Access Assessment Report

The New Primary School in Mulgoa Rise

Project:	The New Primary School in Mulgoa Rise
Reference No:	113966B-Access-MRPS-r5
Date:	17 August 2021
Client:	NBRS Architecture
Client Contact:	Johnsen Lim
Email:	johnsen.lim@nbsarchitecture.com
BCA Logic Project:	Alex Newberry
Direct:	0466 811 720
Email:	anewberry@bcalogic.com.au

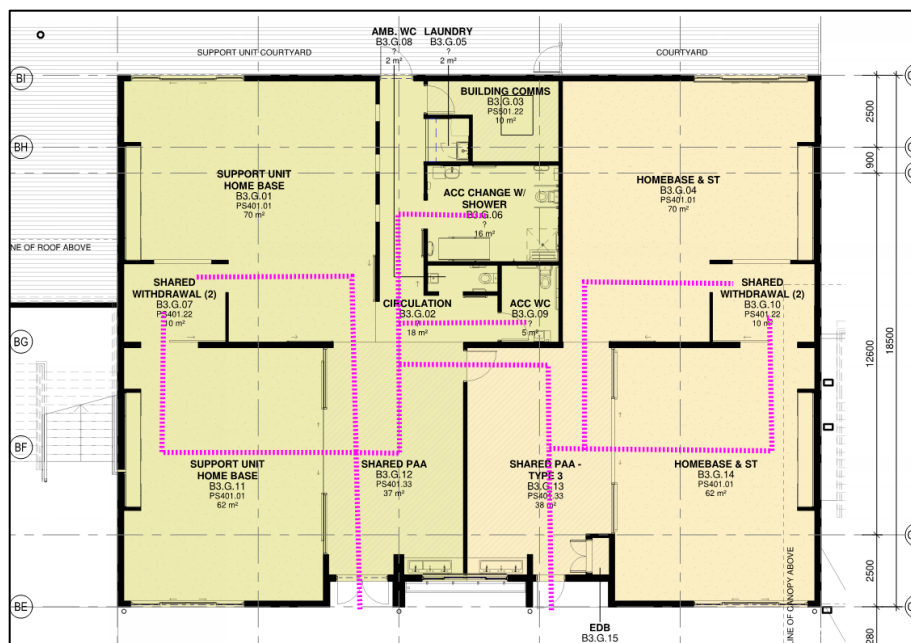
(a) Accessible entry / doorways into each Block: Design team to consider and identify the accessible entry doors into each block and the accessible doors between learning spaces within each Block.

- Block B3 Ground Floor is an example below:
- Accessway shall be provided from both Shared Practical Activities areas then via internal accessible sliding doors into each Homebase. Refer Purple lines below for accessway into all accessible rooms. Internal sliding doors require 530mm latchside clearance which is not provided in current design.

- Rear northern Homebase sliding doors are required to be accessible to access courtyard decking. External sliding doors have challenges to being accessible: must have flush thresholds and have no more than 20N opening force. To be further reviewed.

- Internal sliding doors can generally achieve no more than 20N opening force for top hung doors with the correct sliding door hardware. Although, consideration should be given to size of doors and how to achieve 20N opening force.

- Architect to nominate accessible entry doors and pathways within buildings.
